EO 20-85B-6B

LIST OF  
OVERHAUL MODIFICATIONS  
LIQUIDOMETER - GENERAL

MODIFICATION

REPLACEMENT OF COVER  
HOUSING GASKETS

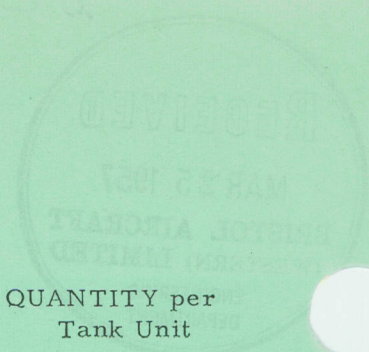
1 To provide more effective sealing of tank unit housing and a gasket less easily damaged when housing is opened for inspection purposes.

(a) The following procedure is to take place on overhaul of the following tank units:-

- (1) Discard gasket Part EA17638-1
- (2) Replace above with gasket Part EA17638-5.

(b) The following procedure is to be followed on overhaul of the following tank unit:-

- (1) Discard gasket Part EA17638-4.
- (2) Replace above with gasket Part EA17638-6.
